TECHNICAL PROCEDURE

TRAILER SUSPENSION SYSTEMS

SUBJECT: Plumbing the New
Three-way Push / Pull Valve

LIT NO: L1146

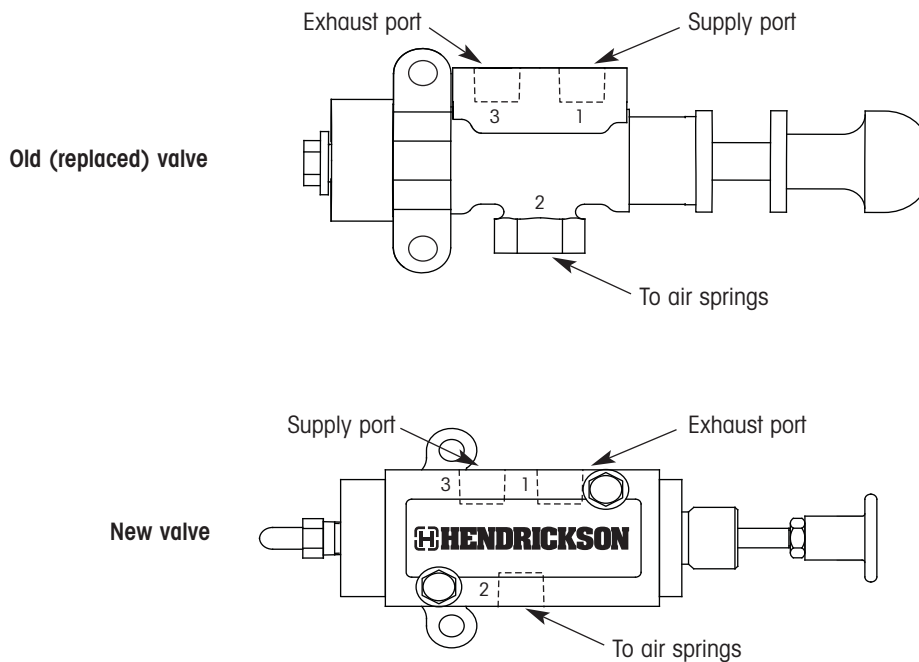
Earlier this year, Hendrickson Trailer Suspension Systems introduced a new three-way push / pull valve to replace the one used in AK-147 and AK-148 manual dump kits. At that time, the new valve was described as identical to the one being replaced. Although the valve functions properly, it has come to our attention that the new valve plumbing orientation is not identical to the "old" valve.

For the handle operation to remain consistent with the old valve, the exhaust must be plumbed to the port closest to the handle on the new valve as shown below.
